**City of Bellevue
Development Services Department
Land Use Staff Report**

Proposal Name: Cacabelos Buffer Restoration

Proposal Description: Land Use review of a Critical Areas Land Use Permit for restoration of a wetland buffer to remove unpermitted fill material and a Vegetation Management Plan.

File Number: 11-103262-LO

Figure 5

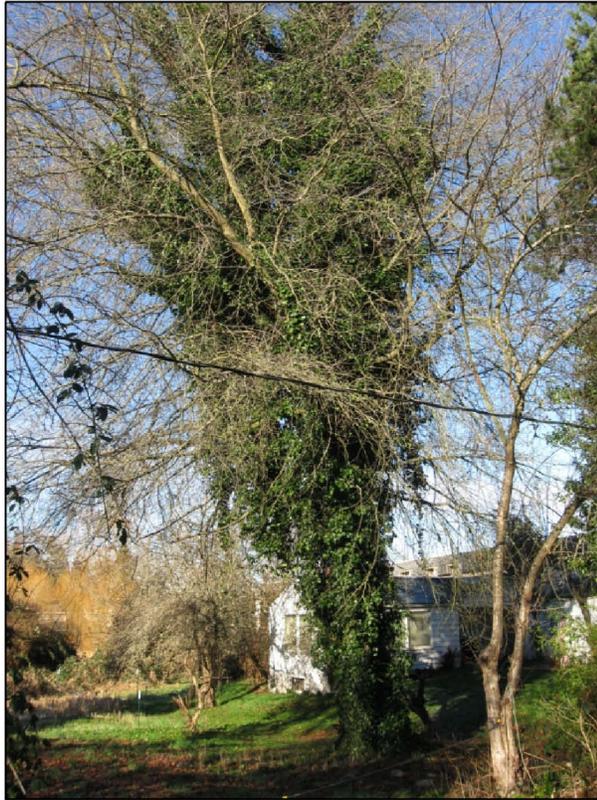
Native plants are proposed to be installed in the wetland buffer and the area of fill restored with an erosion seed mix of native grasses. The proposed plant restoration includes Yellowtwig Dogwood, Sitka Willow, Western Spirea and 4 trees as conditioned above.

PRELIMINARY RESTORATION PLAN (09-125135)

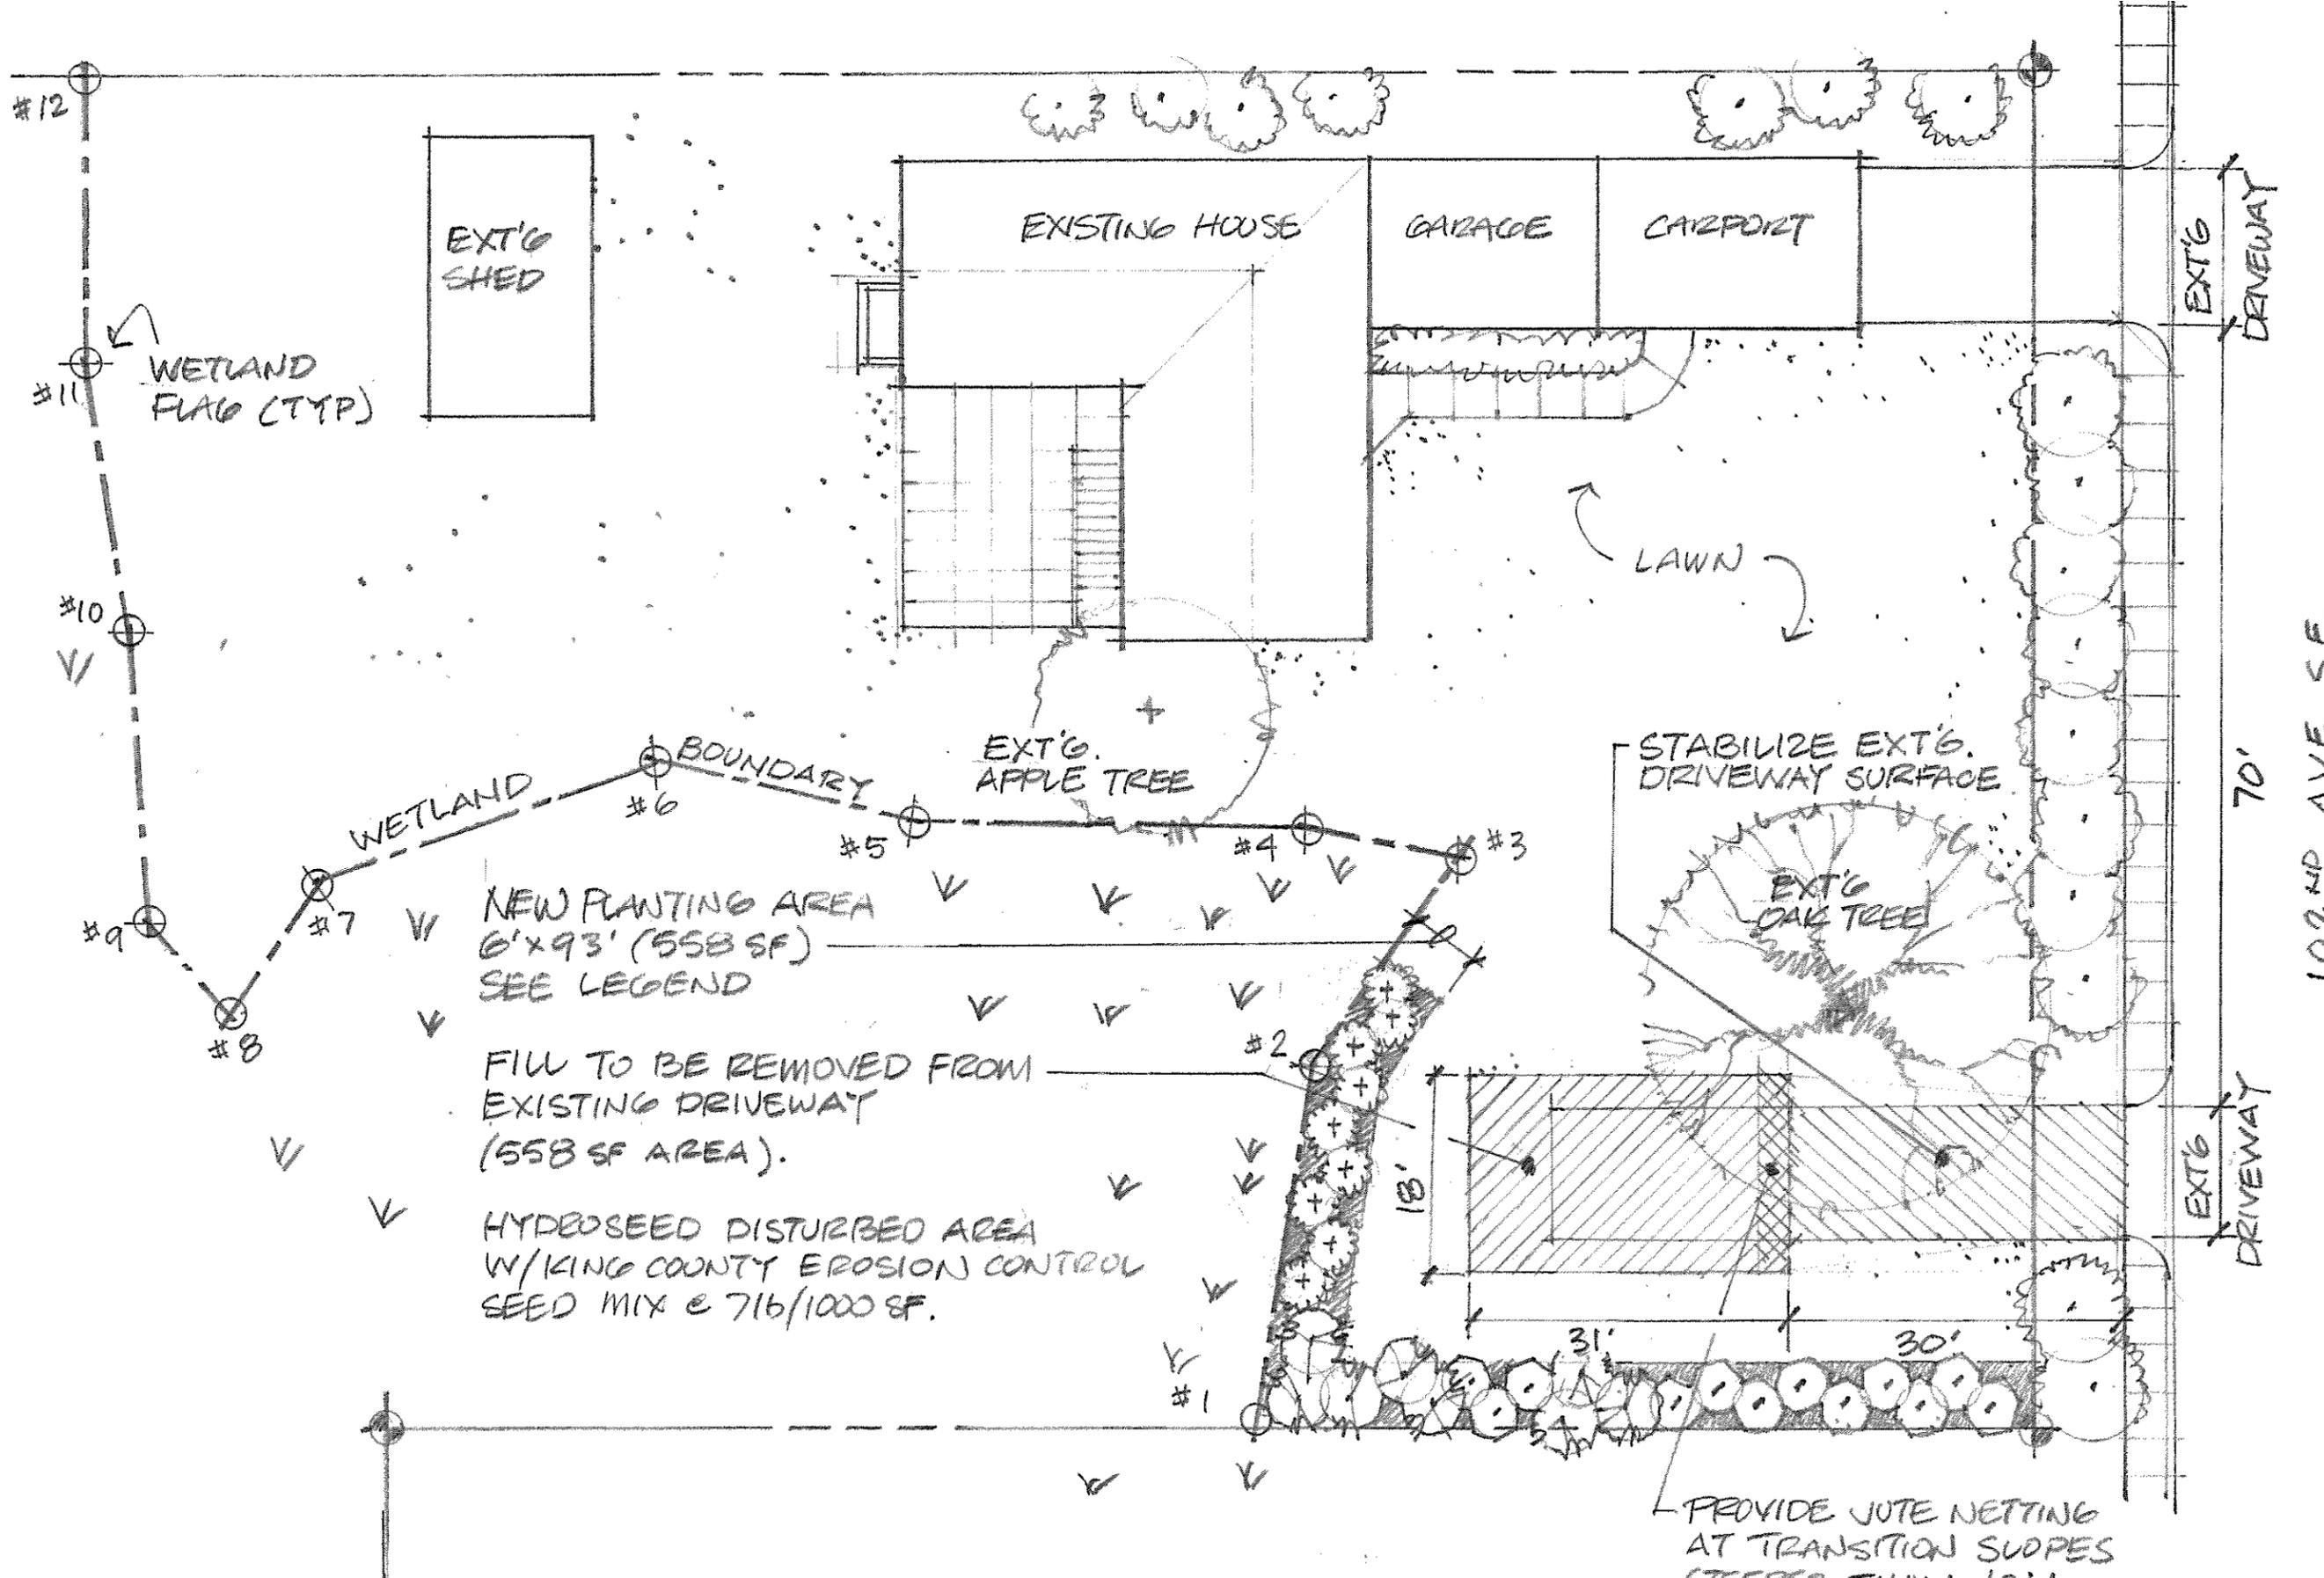
- 4. Revised Planting Plan:** As discussed in section III of this report, four trees of either Oregon Ash, Sitka Spruce, Black Cottonwood, Pacific Willow, and/or Western Red Cedar are required as mitigation for the oak tree to be removed. A revised planting plan is required as part of the clearing and grading permit application which shows the four trees.
